BRUNSWICK STEAM ELECTRIC PLANT, UNIT NOS. 1 AND 2
DOCKET NOS. 50-325 AND 50-324/LICENSE NOS. DPR-71 AND DPR-62
RESPONSE TO REQUEST FOR ADDITIONAL INFORMATION REGARDING
REQUEST FOR LICENSE AMENDMENTS - EXTENDED POWER UPRATE
(NRC TAC NOS. MB2700 AND MB2701)

Response to Request for Additional Information (RAI) 20

Response to Request for Additional Information (RAI) 20

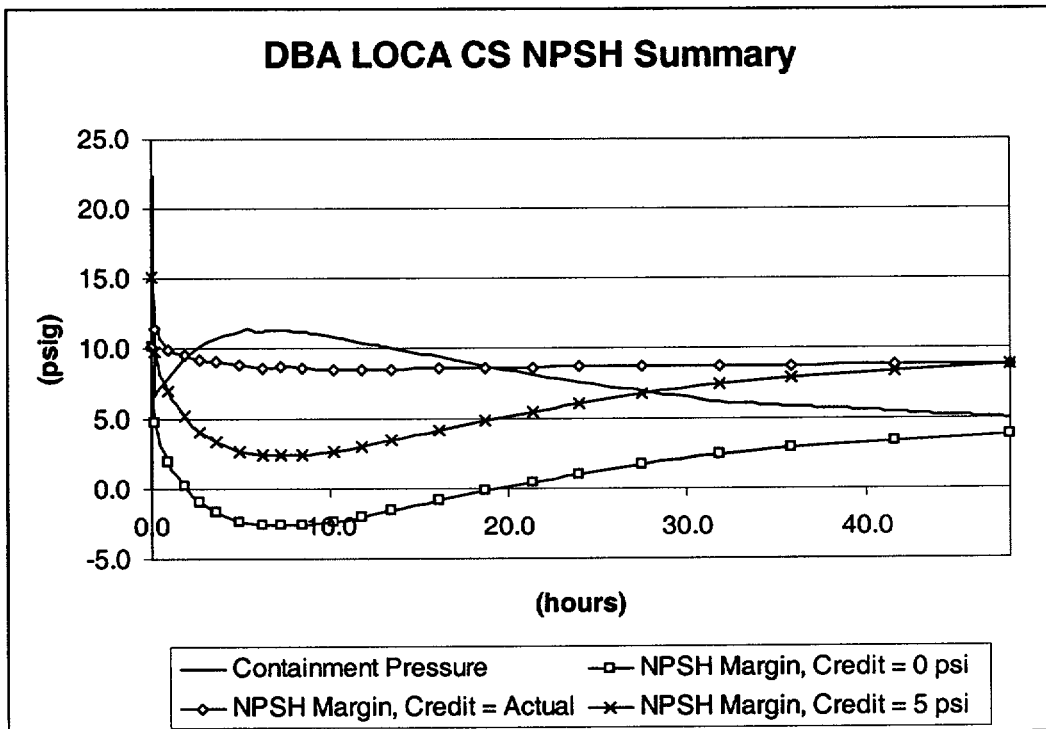
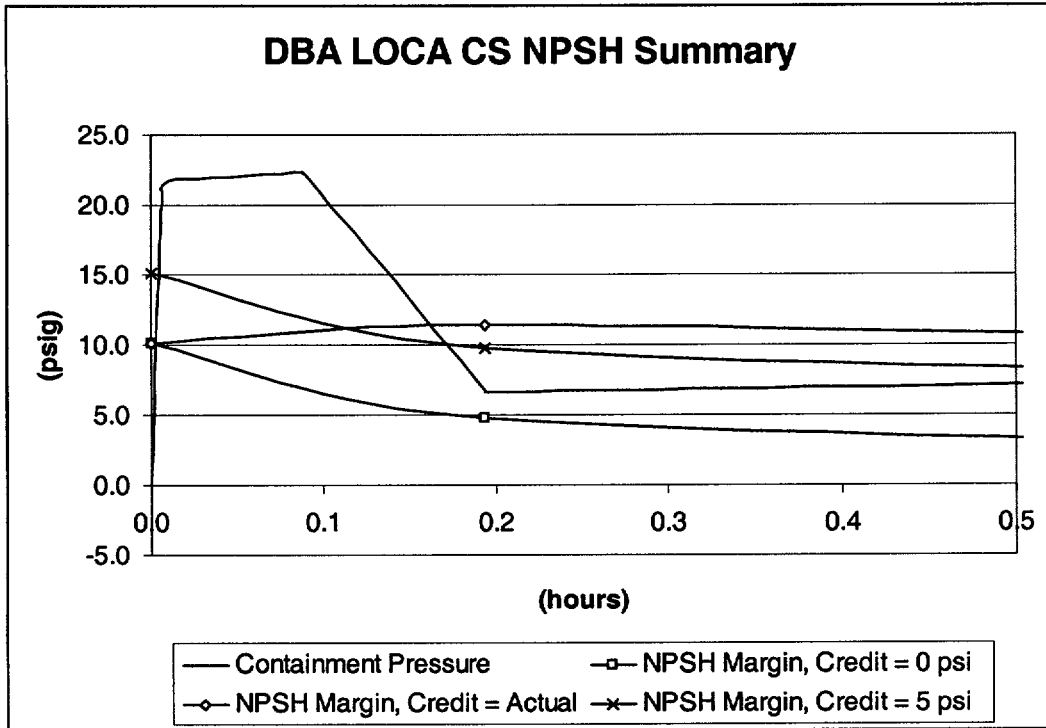
Please provide (1) a plot of long term RHR NPSH requirements based on Table 7-1 of CP&L's EPU amendment request dated August 9, 2001, and (2) a plot of long term CS NPSH requirements based on Table 7-2 of CP&L's EPU amendment request dated August 9, 2001.

The following graphs provide the requested information.

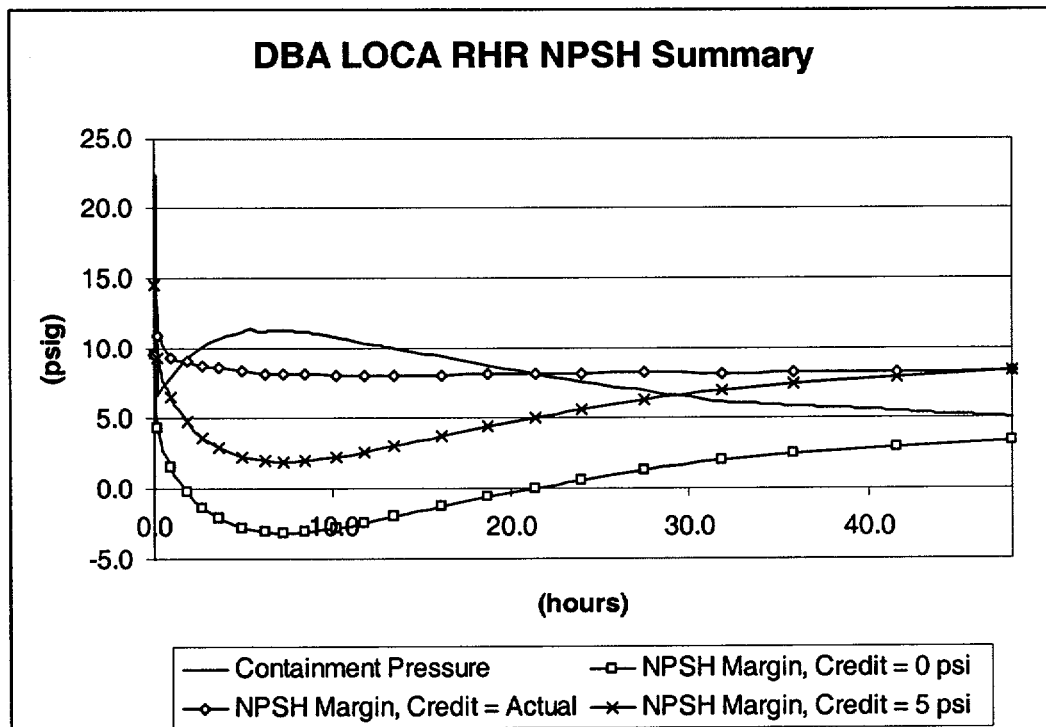
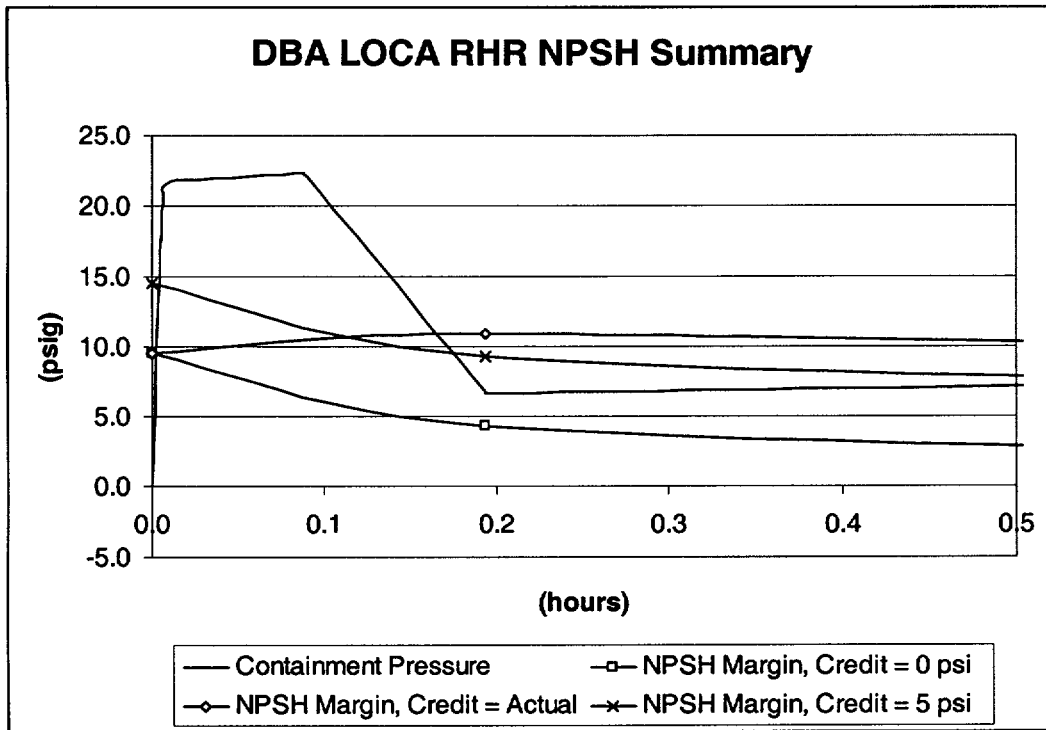
Please provide (1) a plot similar to "Figure 7 - Uncontrolled Drywell Hydrogen and Oxygen Concentrations for EPU," of the RAI 14 response, showing Controlled Drywell Hydrogen and Oxygen Concentrations for EPU and (2) a plot similar to "Figure 8 - Uncontrolled Wetwell Hydrogen and Oxygen Concentrations for EPU," of the RAI 14 response, showing Controlled Wetwell Hydrogen and Oxygen Concentrations for EPU.

The following figure provides the controlled and uncontrolled concentrations of hydrogen and oxygen for the containment drywell and wetwell mixed volume.
